SUPPLEMENTAL SITE PLAN

Easton Manor Senior Housing Complex

Preliminary Fire System Plan

P1

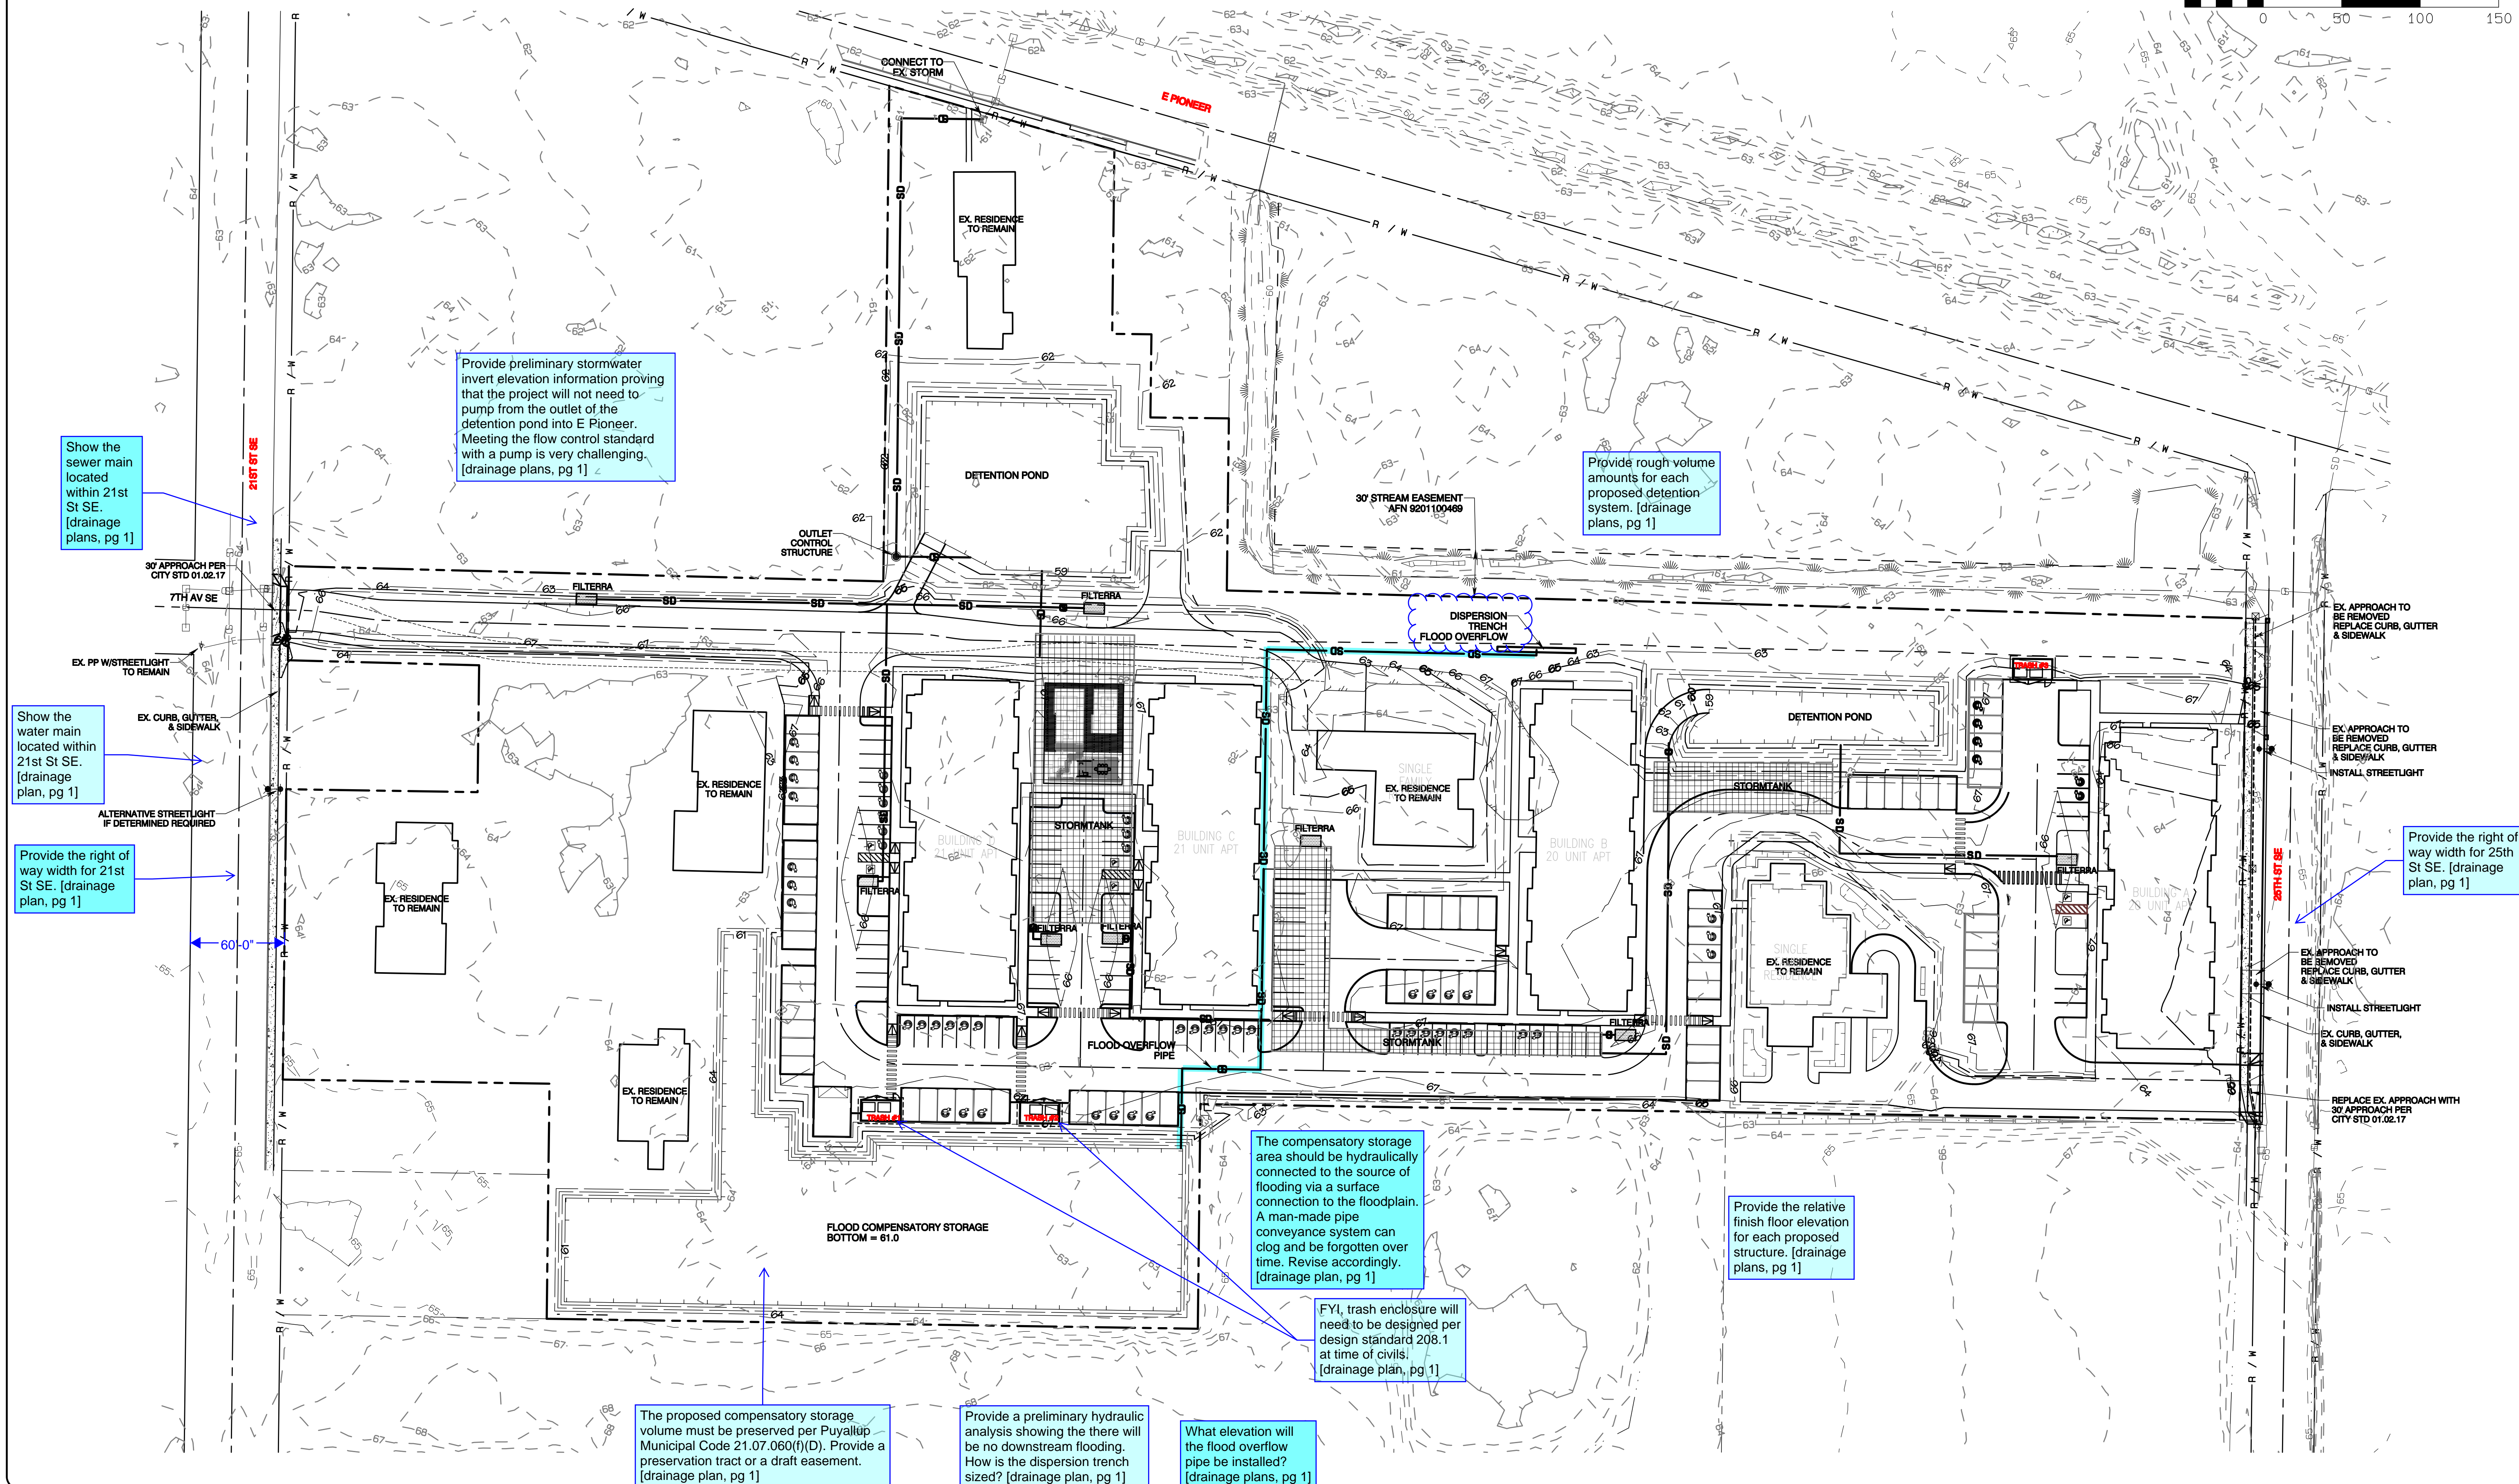
Provide a legend distinguishing existing vs proposed linetypes and hatches. [drainage plan, pg 1]

Show the pedestrian access route from the public right of way to on-site structures. [site plan]

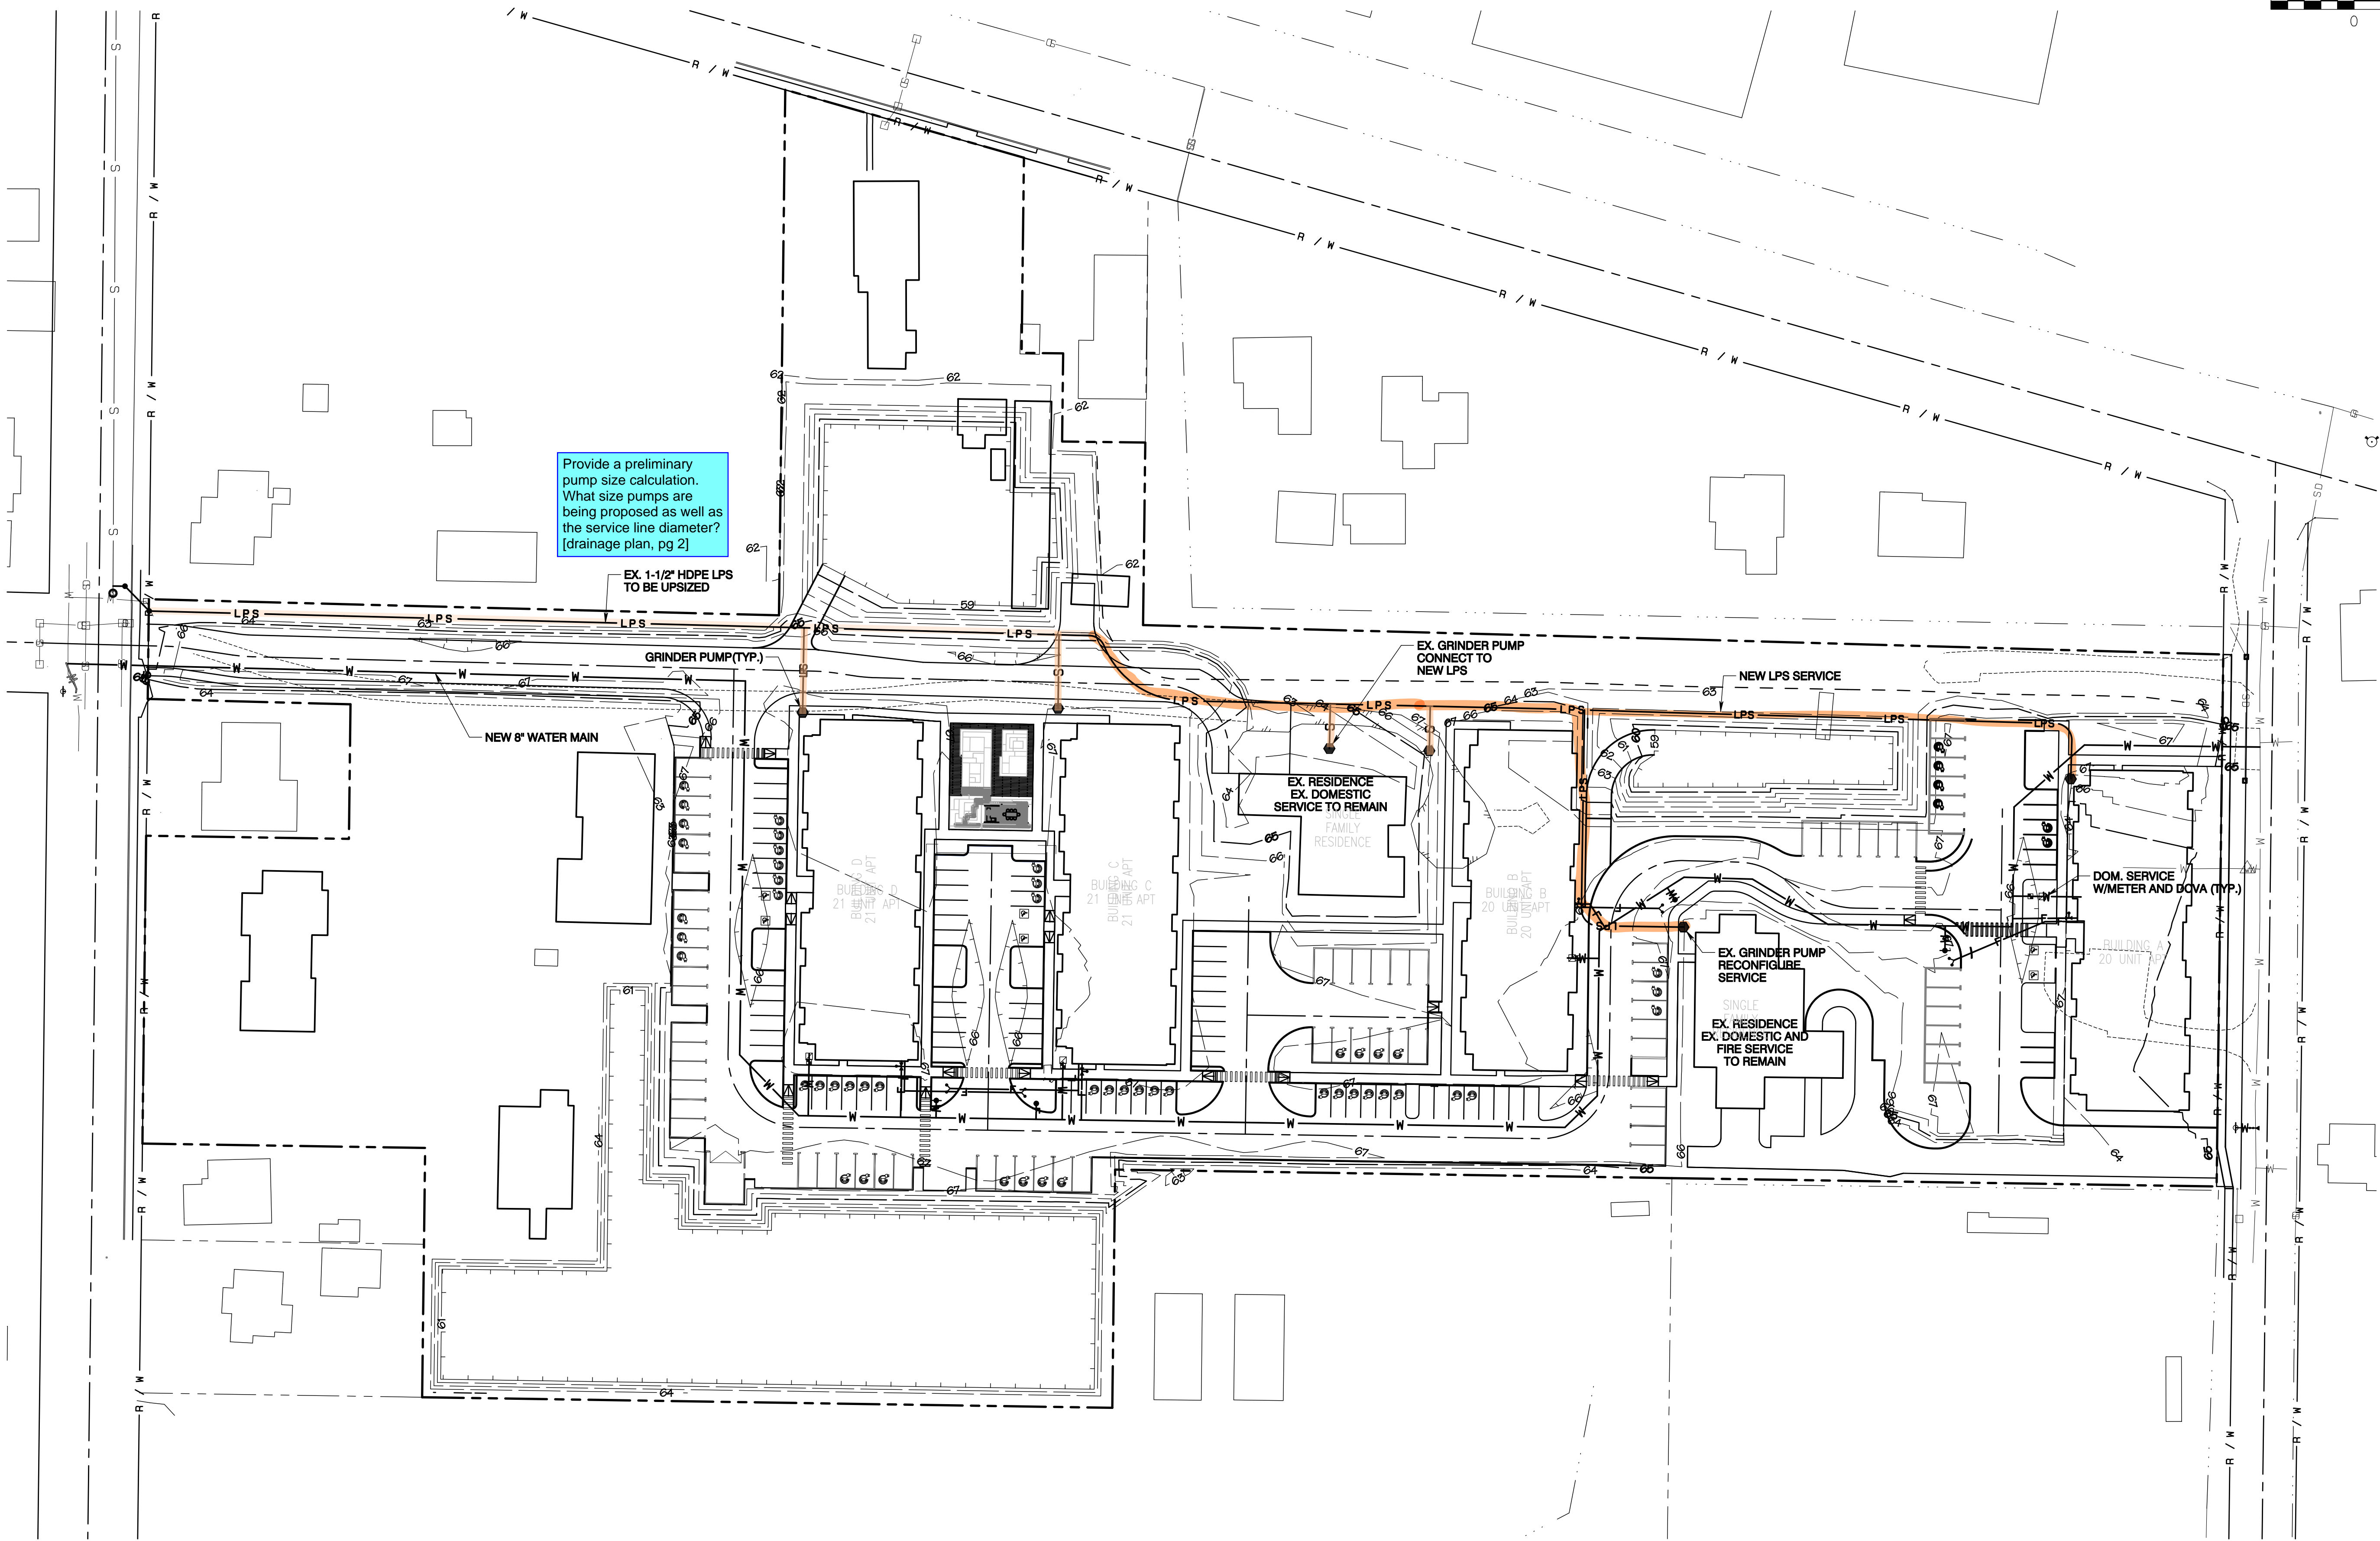
Provide a preliminary pump size calculation. What size pumps are being proposed as well as the service line diameter? [drainage plan, pg 2]
